Safety Defect and Noncompliance Report Guide for Equipment
PART 573 Defect and Noncompliance Report¹

Subject: Part 573 Defect and Noncompliance Responsibility Report – Anti-stow interlock
Reference: FMVSS 403 compliant Ricon S & K-series Public and Private Use Lifts

Ricon Corporation
Part 573 Defect and Noncompliance Responsibility Report
Anti-stow Interlock – (S6.10.2.3)

RE: Equipment Safety Standard Non-Compliance Notification - #07E-097

Placement of Test weight for Anti-Stow Interlock Adjustment - Recall 07E-097

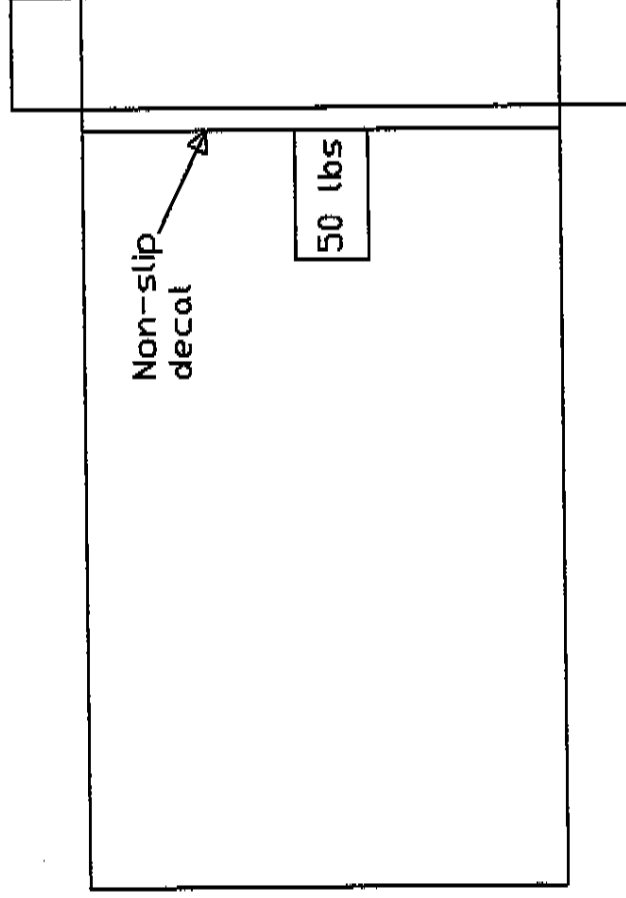
- 1. Park the vehicle in a safe location.**
- 2. Open the lift door(s) and deploy the lift to the floor level position.**
- 3. Place the 50lb test weight oriented lengthwise along the length of the platform and at the most inboard end of the platform operation volume. There is a non-skid decal on the platform that defines this location.**

- 4. Depress the Stow button. Platform should not stow. If platform does not stow, the lift is properly adjusted. If platform stows with the test weight, continue with the following procedure:**

- a. Remove the pump cover and locate the anti-stow pressure switch.**
 - b. Remove the “jam” set screw in the center of the switch and turn the adjusting set screw one half turn counterclockwise.**

- c. Place the test weight in the prescribed location.**
 - d. Adjust pressure switch in the counterclockwise direction until such point where when the Stow function is depressed, the lift will not stow with the test weight in the prescribed location. It is good practice to adjust the switch 1/8-1/4 turn at a time.**

- e. Once pressure switch is set, replace the lock screw. Note – When tightening the lock screw, the adjustment screw may turn up to ¼ turn.**
 - f. Re-test to make sure lift will not stow with test weight in prescribed location**

- g. Remove test weight**
 - h. Depress the stow switch. Lift should stow with empty platform.**

Placement of Test weight for Anti-Stow Interlock Adjustment - Recall 07E-097

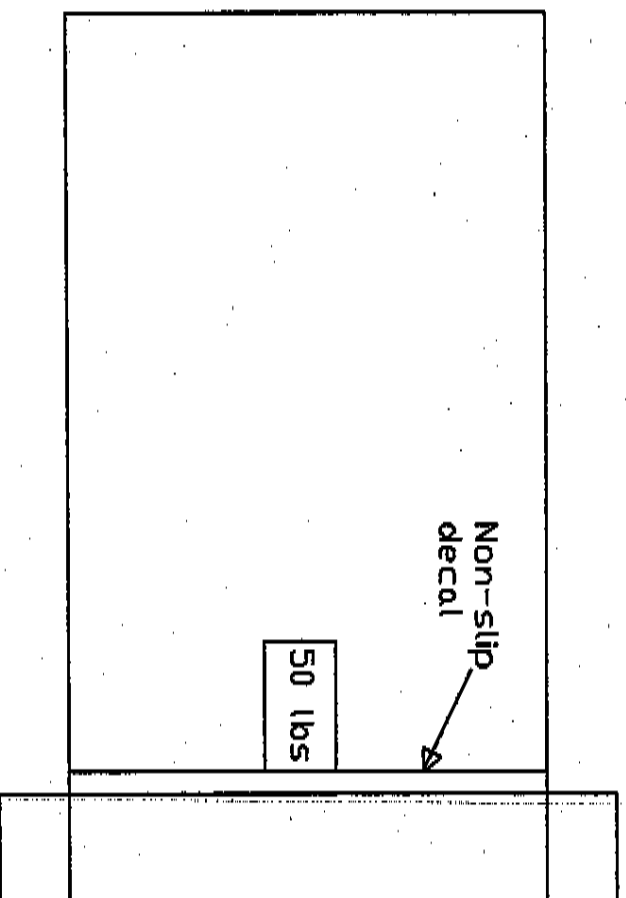
- 1. Park the vehicle in a safe location.**
- 2. Open the lift door(s) and deploy the lift to the floor level position.**
- 3. Place the 50lb test weight oriented lengthwise along the length of the platform and the most inboard end of the platform operation volume. There is a non-skid decal on the platform that defines this location.**

- 4. Depress the Stow button. Platform should not stow. If platform does not stow, the lift is properly adjusted. If platform stows with the test weight, continue with the following procedure:**

- a. Remove the pump cover and locate the anti-stow pressure switch.**
 - b. Remove the "jam" set screw in the center of the switch and turn the adjusting set screw one half turn counterclockwise.**

- c. Place the test weight in the prescribed location.**
 - d. Adjust pressure switch in the counterclockwise direction until such point where when the Stow function is depressed, the lift will not stow with the test weight in the prescribed location. It is good practice to adjust the switch 1/8-1/4 turn at a time.**

- e. Once pressure switch is set, replace the lock screw. Note – When tightening the lock screw, the adjustment screw may turn up to ¼ turn.**
 - f. Re-test to make sure lift will not stow with test weight in prescribed location.**

- g. Remove test weight.**
 - h. Depress the stow switch. Lift should stow with empty platform.**
